# GENERAL PLAN OF KALABAGH HEAD WORKS

# KALABAGH HEAD WORKS

PUNJAB ENGINEERING CONGRESS  
1942.

## DISCUSSION

**GENERAL PLAN OF KALABAGH HEAD WORKS**  
 SHOWING THE POSITIONS OF SUMPS AND MIXERS

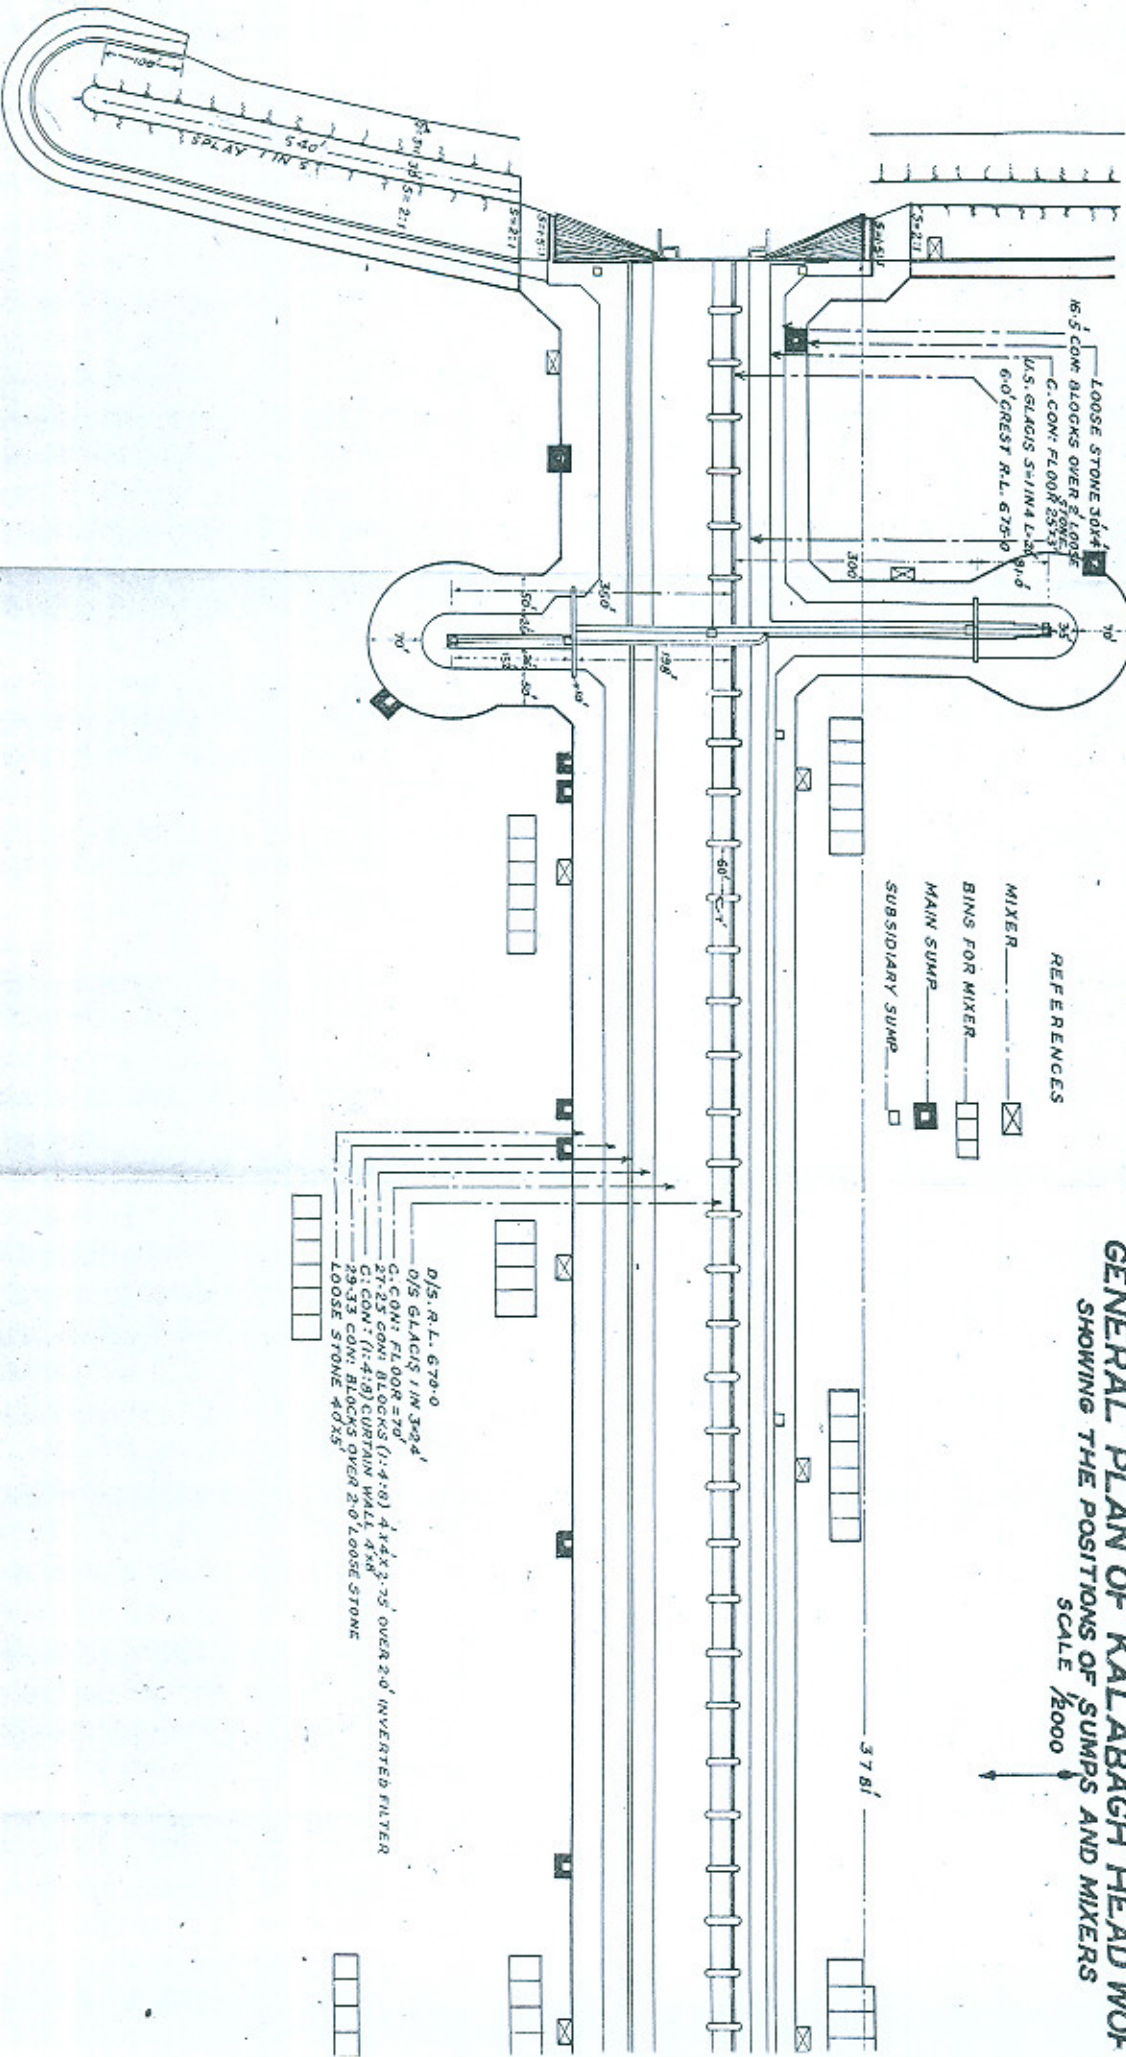
3. In describing the construction of the Weir under *Pumping* (page 38) it was stated that 4 main sumps were made on either flank

in the undersluices area and six in the Weir area. On the Plan (Plate No. II) eight were shown in the Weir area, making a total of 16 main sumps. The discharge from each main sump was said to vary from 5 to 8 cusecs. A total maximum of 30 to 50 cusecs was said to have been attained. This indicated that only about 6 main sumps were in operation at one time. Was that so? It would be helpful if the area served by each main sump and its corresponding discharge were given, so that one could design future pumping installations with knowledge.

Regarding the sumps, the author pointed out that some of the sumps shown on the plan were twin-sumps and that the whole of the weir area was not opened up at the same time, as the pumping in the weir was originally restricted to R. D. 1150, as mentioned on p. 39, and they did not generally have more than 8 main sumps working at a time.

FIG I

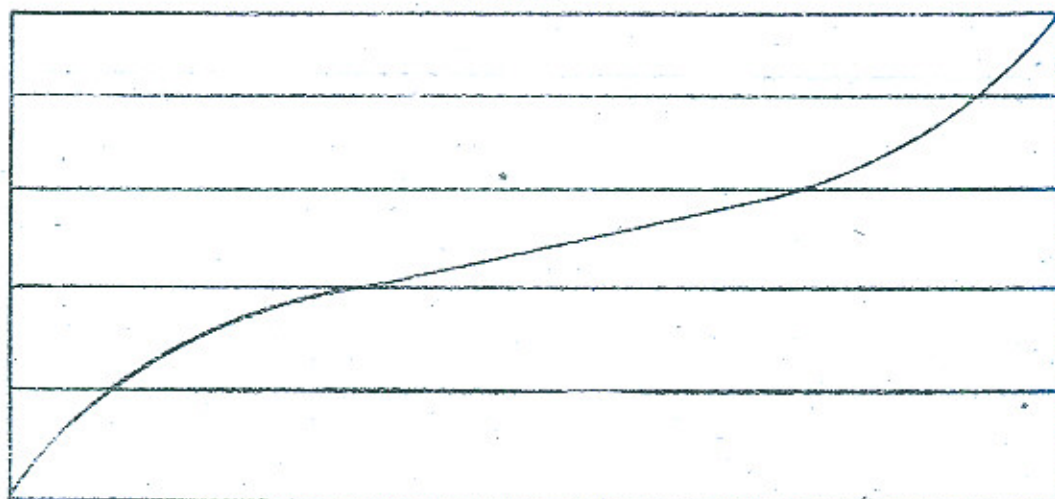
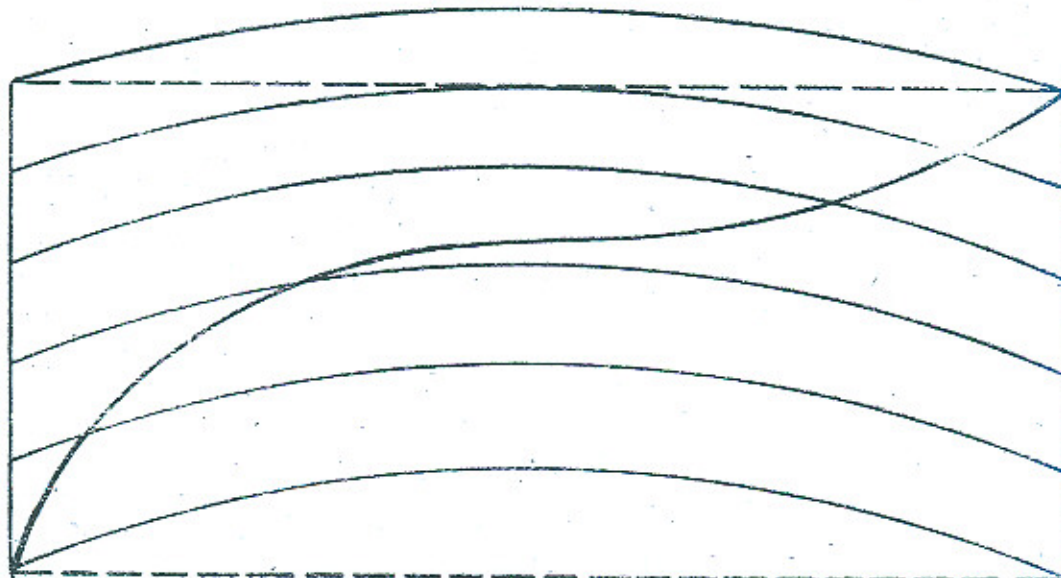
DR. N. K. BOSE remarked that the only point on which he could speak with some confidence was given on page 52 "Pressure Observations". In this case the author had given the method of finding out the actual hydraulic gradient line when the flow was not the same as in the cases dealt with by the speaker in the Central Board Publication No. 12 "Design of Weirs on sand foundations". In the case under review the two levels upstream and downstream were maintained on certain R. Ls., artificially by putting in a battery of pumps on the upstream and downstream side. In consequence of this, the hydraulic gradient line when there was no weir present would be given by the attached figure.

It will be seen how the two cases differ. In one case the streamlines concentrate to the two lines of pumps and in other case they are parallel, flowing from right to left. It was apparent that the effect of putting an obstacle such as a weir structure would be different on these two different configurations of streamlines. It would be possible by assuming that the pressure distribution due to the original field of flow and to the imposed boundary conditions could be added up linearly and the final pressures obtained. How far that would be correct was still to be seen but he could not understand how the Author said on page 53. 1st line that the ratio of  $(b)$  minus  $(a)$  to  $(c)$  minus  $(a)$  at any point gave the value of  $\phi$  at that point.

The author remarked that Dr. Bose had failed to understand the method adopted for calculating the fall of pressures under the weir while pumping was in progress. In this case owing to seepage inflow the subsoil water surface in the vicinity of a sump sloped towards the sump. The observations of the water table away from the sump would not give the sump level, but a higher one—the difference representing the seepage flow potential. The problem was to find what the levels would be were there no seepage inflow. In this case were the water levels maintained upstream and downstream at the same level the subsoil level below would be a horizontal plane. If this level was varied they would get a series of horizontal planes representing static pressure contours. And if the water level was maintained at a high level upstream and a low one downstream the subsoil water level would vary in between following some such curves as that shown in diagram I. The difference of level between any two points on the curve represented flow potential due to the difference of level upstream and downstream. With seepage inflow the planes corresponding with equal water levels upstream and downstream were distorted and became surface convex upwards. The static pressure at any point on these curves was that of the free water level and the difference in level represented the flow potential due to the seepage inflow. The actual form of these surfaces could be determined by observation resulting in curves of the form of Fig. II. With a water level upstream higher than downstream the hydraulic gradient

could similarly be found by observations on a line which cuts the equal pressure contours at various points. Levels on this line might be resolved into three components:—

- (a) Static pressure.
- (b) Seepage flow potential due to seepage inflow.
- (c) Seepage flow potential due to the difference of level upstream and downstream.

Relative to the contours of Fig. II, they represented (c) only, *i.e.* they were identical with the levels of Fig. I relative to the static contours.

The author remarked that actually, at Kalabagh only the upper and lower contours were found by observations, intermediate contours being estimated on the assumption that intervals between contours would be proportional to the distortion of the contours at the upper and lower levels and would vary arithmetically in between. Some error might result from this assumption but it was not likely to be great.
